# STAFF REPORT

DATE: June 11, 2021

RE: 210-216 Duval Street (**Landscape Code Review**) <sup>KD</sup>

FROM: Karen DeMaria, City of Key West Urban Forestry Manager

PROPOSED SITE  
LANDSCAPING AND  
DRAINAGE PLAN

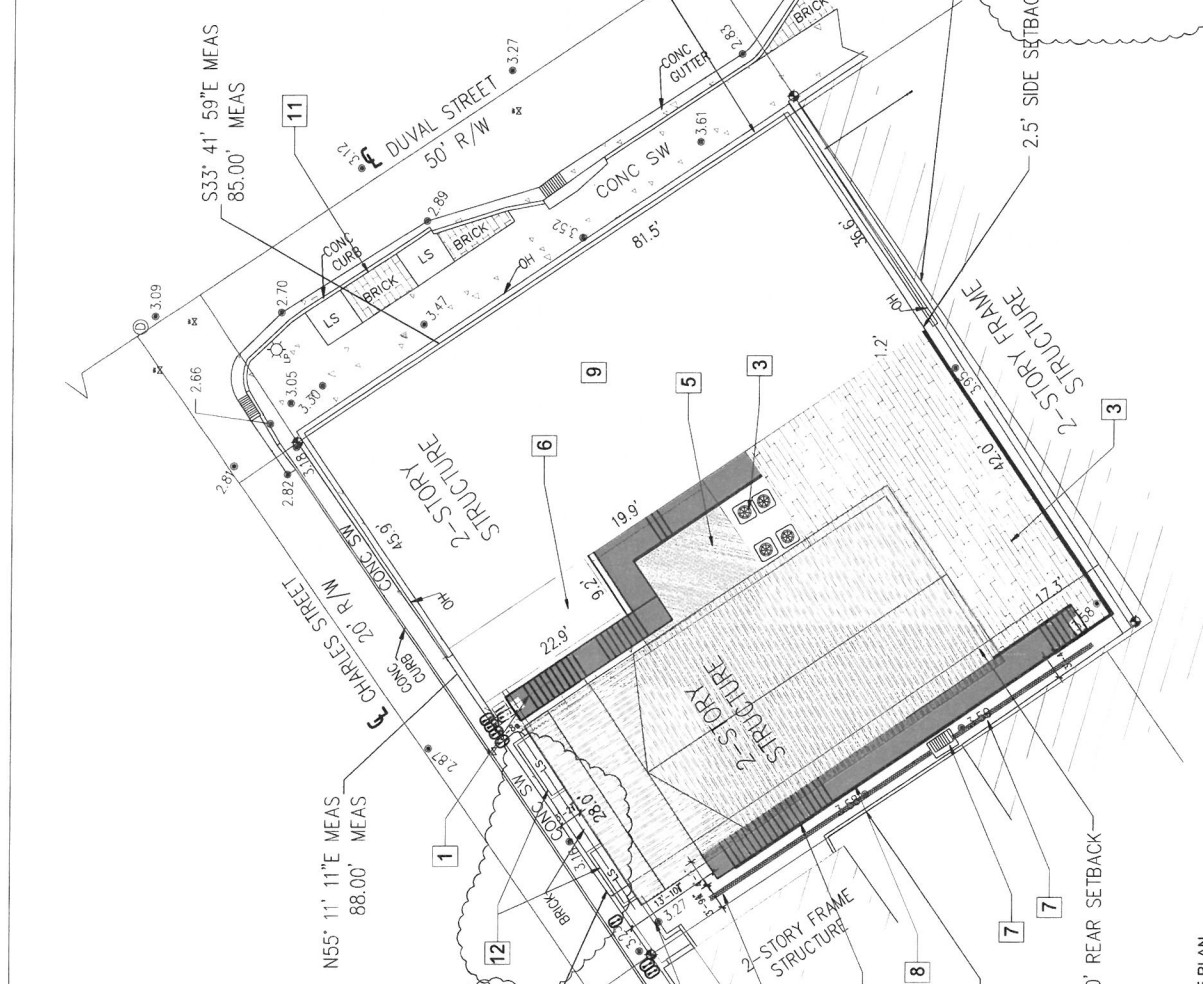
The applicant is proposing to create two planter boxes along Charles Street with shrubs. At this time it is not known if the existing planter boxes will be removed and rebuilt, what species of plants will be planted, or how many shrubs will be planted. The applicant has also proposed a donation to the City tree/landscaping fund.

Street buffer requirements equate to 3.4 trees for Duval Street and 3.5 trees for Charles Street. A tree by definition in the landscape code is at least 2.5 inches diameter. The City Tree Ordinance has a mitigation fee of \$200 per inch (Sec 110-327.7.a), therefore, each tree under the landscape code requirements would have a value of \$500 and the donation value for the Duval Street requirement would be \$1,700 and for Charles Street would be \$1,750 (not counting any shrubs) for a total donation of \$3,450.
